SUNDRY NOTICES AND REPORTS ON WELLS

8. Well Name and No.
JAMES RANCH UNIT DI2 193H

BOPCO, LP requests approval of the following changes to the original APD:

Directional Drill Plan
Drilling Program
C102
BOP/Choke Design
Flex Hose Variance

BOPCO, LP
James Ranch Unit DI2 193H
5000# BOP

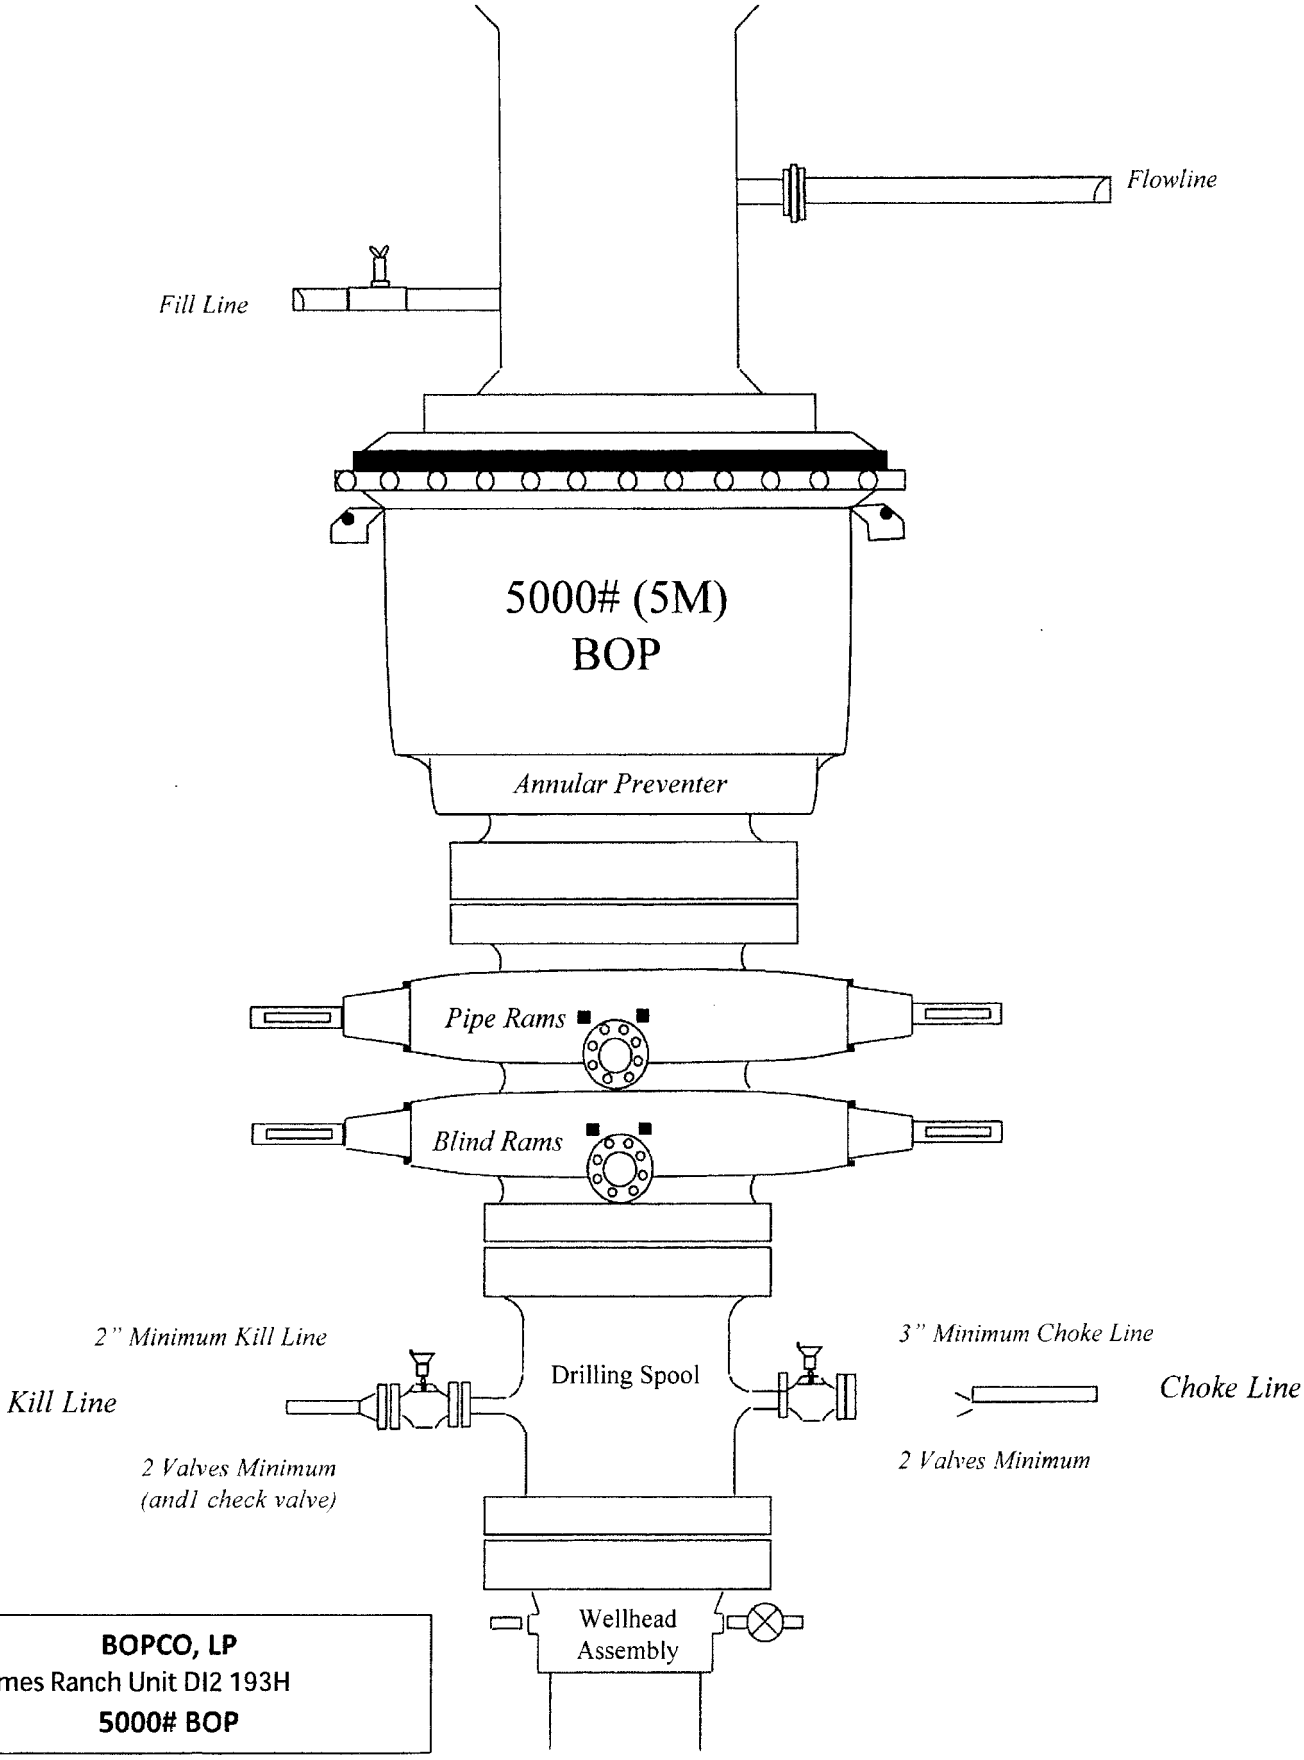
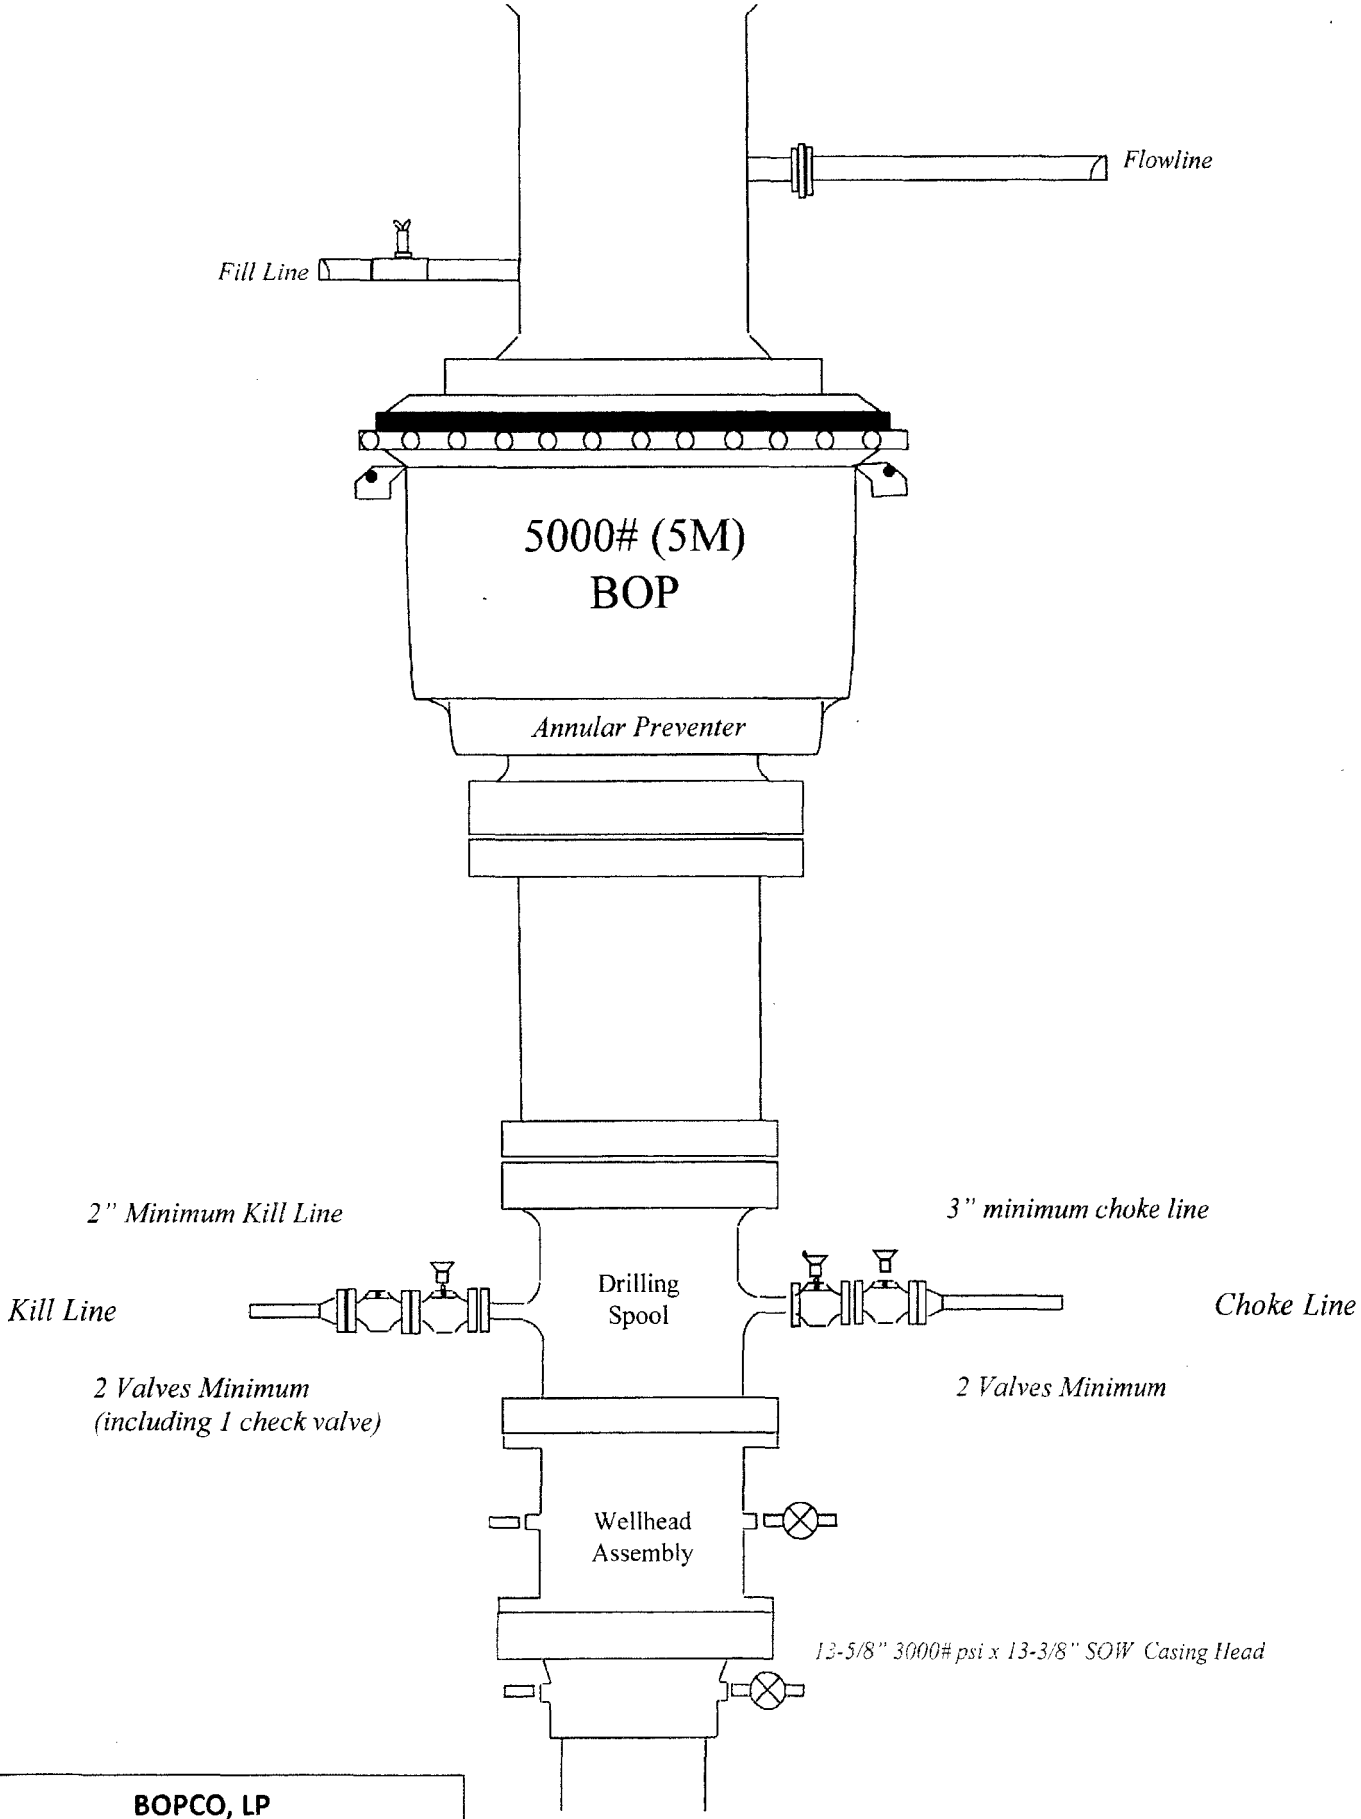
The blow out preventer equipment (BOP) for this well consists of a 13-5/8" minimum 5M Hydril and a 13-5/8" minimum 5M Double Ram BOP. MASP should not exceed 3388 psi.

All BOP testing will be done by an independent service company. Annular pressure tests will be limited to 50% of the working pressure. When nippling up on the 13-5/8" 5M bradenhead and flange, the BOP test will be limited to 5000 psi. When nippling up on the 9-5/8", the BOP will be tested to a minimum of 5000 psi. All BOP tests will include a low pressure test as per BLM regulations. The 5M BOP diagrams are attached. Blind rams will be functioned tested each trip, pipe rams will be functioned tested each day.

2. Minimum working pressure of the blowout preventer (BOP) and related equipment (BOPE) required for drilling below the surface casing shoe shall be **5000 (5M)** psi.

3. 5M or higher system requires an HCR valve, remote kill line and annular to match. The remote kill line is to be installed prior to testing the system and tested to stack pressure.

5M Choke Manifold Diagram
James Ranch Unit DI2 193H
BOPCO, LP

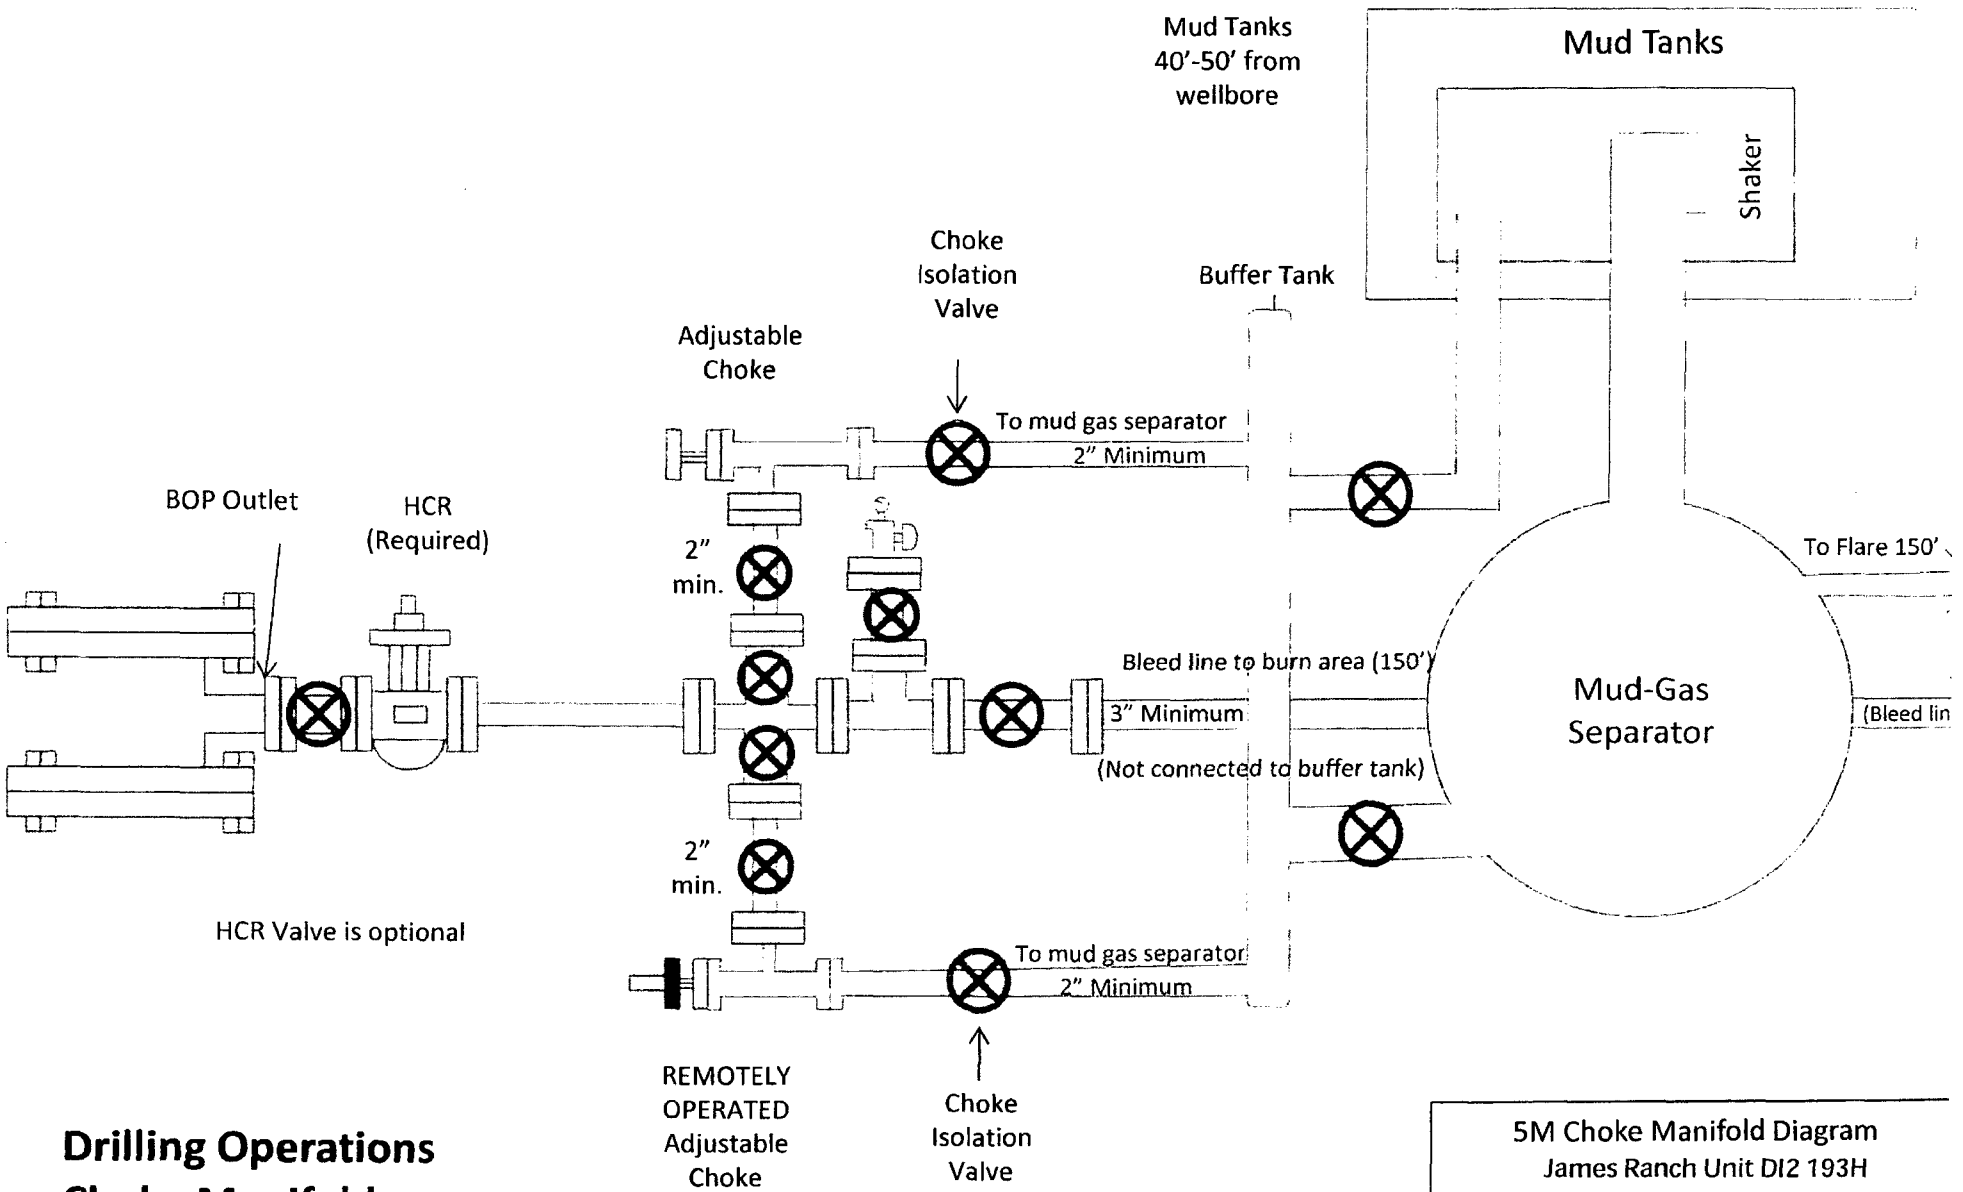
A variance is requested to allow use of a flex hose as the choke line from the BOP to the Choke Manifold. If this hose is used, a copy of the manufacturer's certification and pressure test chart will be kept on the rig. Attached is an example of a certification and pressure test chart. The manufacturer does not require anchors.

1. Variance approved to use flex line from BOP to choke manifold. Manufacturer's specification to be readily available. No external damage to flex line. Flex line to be installed as straight as possible (no hard bends).

2. If a variance is approved for a flexible hose to be installed from the BOP to the choke manifold, the following requirements apply: The flex line must meet the requirements of API 16C. Check condition of flexible line from BOP to choke manifold, replace if exterior is damaged or if line fails test. Line to be as straight as possible with no hard bends and is to be anchored according to Manufacturer's requirements. The flexible hose can be exchanged with a hose of equal size and equal or greater pressure rating. Anchor requirements, specification sheet and hydrostatic pressure test certification matching the hose in service, to be onsite for review. These documents shall be posted in the company man's trailer and on the rig floor.
